## UNION CYCLISTE INTERNATIONALE

Aigle, 20 December 2013  
Ref.: Sport and Technical Department / MM

### Reminder - New regulations on riders' positions for 2014

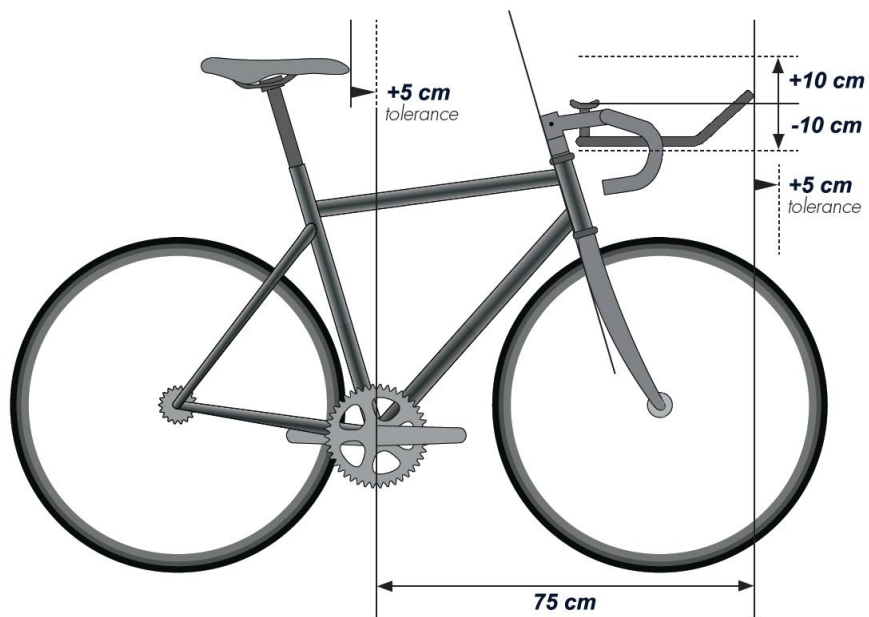
**1.3.013** The peak of the saddle shall be a minimum of 5 cm to the rear of a vertical plane passing through the bottom bracket spindle. This restriction shall not be applied to the bicycle ridden by a rider in a sprint event on track (flying 200 m, flying lap, sprint, team sprint, keirin, 500 metres and 1 kilometre); however, in no circumstances shall the peak of the saddle extend in front of a vertical line passing through the bottom bracket spindle.

The peak of the saddle can be move forward until the vertical line passing through the bottom bracket spindle where that is necessary for morphological reasons. By morphological reasons should be understood everything to do with the size and limb length of the rider.

Any rider who, for these reasons, considers that he needs to use a bicycle of lesser dimensions than those given shall inform the commissaires' panel to that effect **at the time of the bike check** ~~when presenting his licence. In that case, the panel may conduct the following test. Using a plumb-line, they shall check to see whether, when pedalling, the point of the rider's knee when at its foremost position shall not pass beyond a vertical line passing through the pedal spindle (see diagram «Measurements (2)»).~~

**Only one exemption for morphological reasons may be requested; either the peak of the saddle can be moved forward or the handlebar extensions can be moved forward, in accordance with Article 1.3.023.**
